BOARD ACTION REPORT – APPEALABLE ITEM

Project Name: Pierre Delray II

SITE PLAN REVIEW AND APPEARANCE BOARD MEMORANDUM

Meeting: November 19, 2020 | File No: 2019-266-SPM-SPR-CLV | Application Name: Pierre Delray II

1 VIEW FROM BUDDHA SKY BAR
A9a Scale:

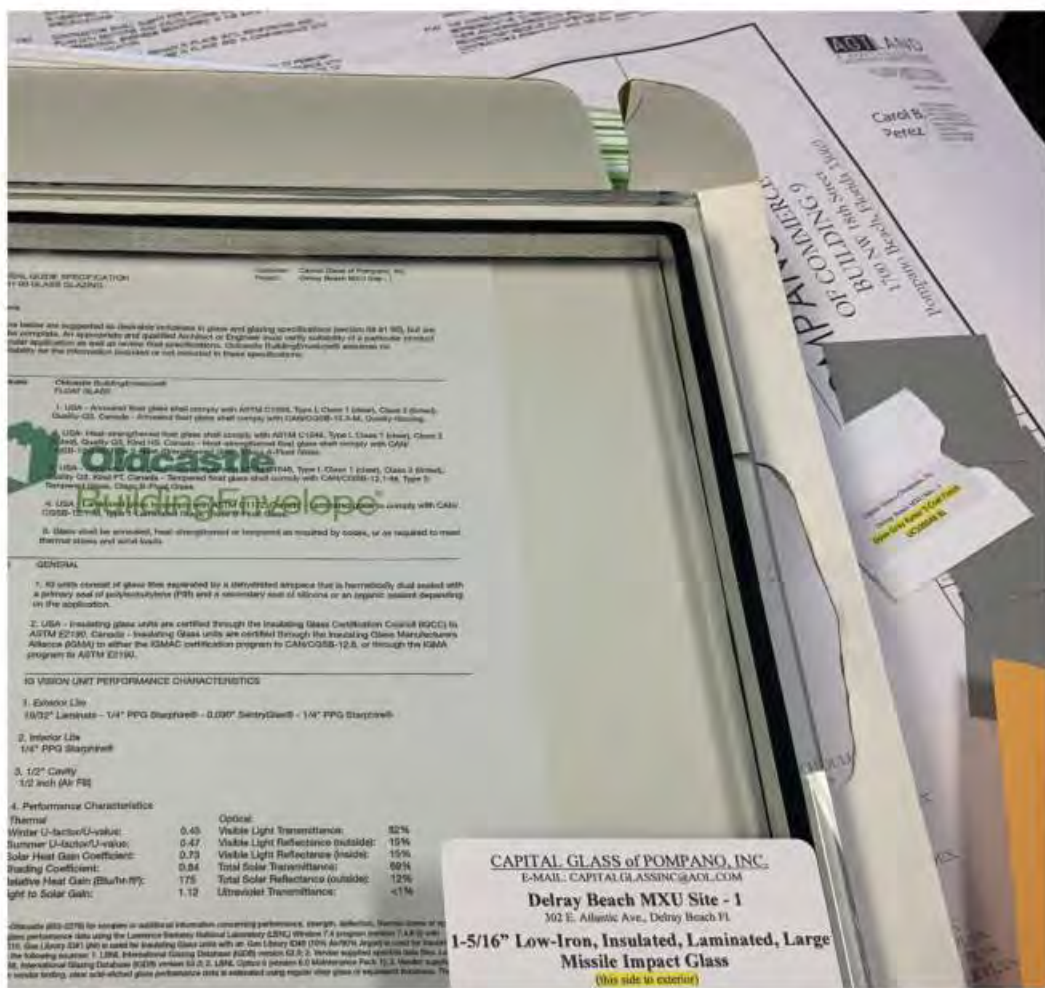
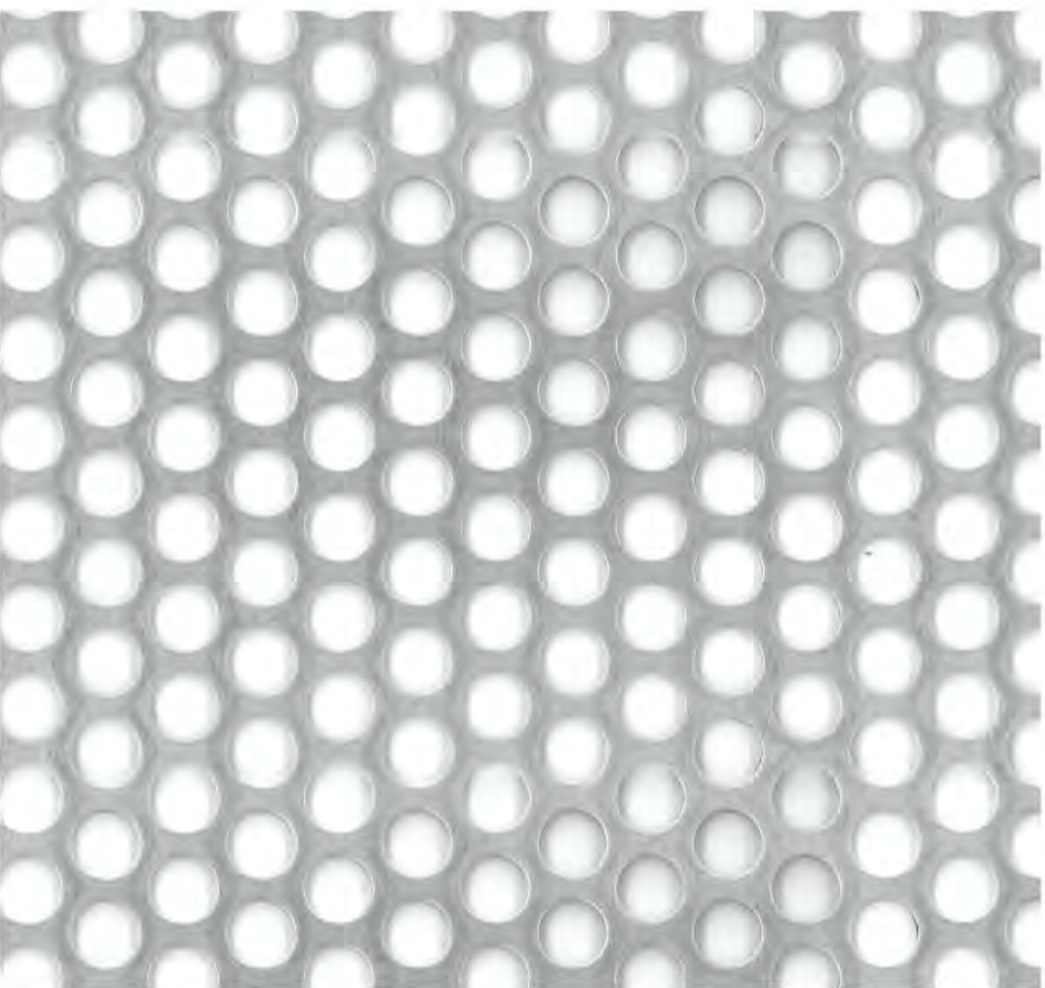
The item was initially presented to the SPRAB at the November 18, 2020 meeting, but was postponed because of comments board made requesting that the applicant revise the architectural elevation to replace the proposed exterior faux green walls with mosaic wall tile. At the November 19, 2020 meeting, the SPRAB approved the revised building elevation with the wall tile revision. See the attached board memo for information.
